**RE: Buckingham Compressor Station, Registration No. 21599**

The Southern Environmental Law Center offers the following comments on the draft air permit for the Atlantic Coast Pipeline, LLC's ("Atlantic") proposed Buckingham Compressor Station, Registration Number 21599 ("Draft Permit"). These comments are submitted on behalf of the Southern Environmental Law Center, Friends of Buckingham, Natural Resources Defense Council, Sierra Club, Shenandoah Riverkeeper, Potomac Riverkeeper, Shenandoah Valley Battlefields Foundation, Virginia Wilderness Committee, Augusta County Alliance, Shenandoah Valley Network, Highlanders for Responsible Development, the Chesapeake Climate Action Network, Wild Virginia, the Allegheny-Blue Ridge Alliance, and Defenders of Wildlife.

**Figure 1: Map of Households Surrounding the Proposed Buckingham Compressor Station**

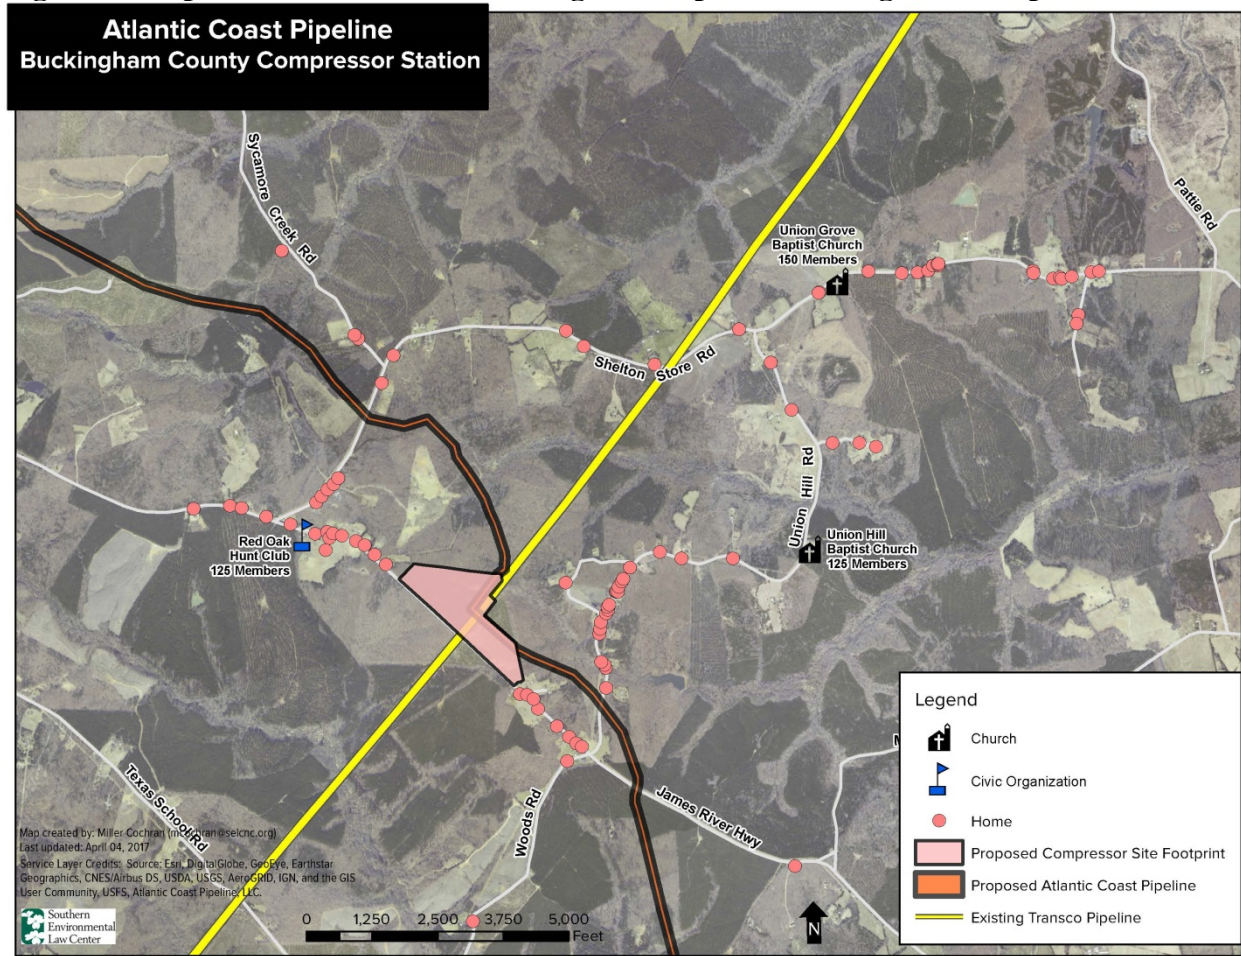
As part of its site suitability analysis, VDEQ determined that the area around the proposed Buckingham Compressor Station is “sparsely populated” and primarily surrounded by forests.<sup>57</sup> This conclusion is not consistent with the denser than average Union Hill community that inhabits the area within a one-mile radius of the site. To reach this flawed conclusion, it appears that VDEQ relied on Atlantic’s use of countywide population density data of 29.6 people per square mile.<sup>58</sup> But this county-level population density data does not reflect the actual characteristics of the neighboring community. As noted above, Friends of Buckingham has identified nearly 100 households in the 1.1 mile radius of the proposed compressor stations. The 75 households surveyed to date are made up of 199 residents.

As seen in Figure 1 below, there are significant clusters of households in the area surrounding the proposed compressor station:

This disparity is significant, and the large number of households that in fact lie close to the proposed compressor station contradict VDEQ’s site suitability conclusion that the area around the Buckingham compressor station is primarily surrounded by forests and sparsely populated. The Air Board must independently consider the unsuitability of this proposed location for a new source of industrial air pollution.
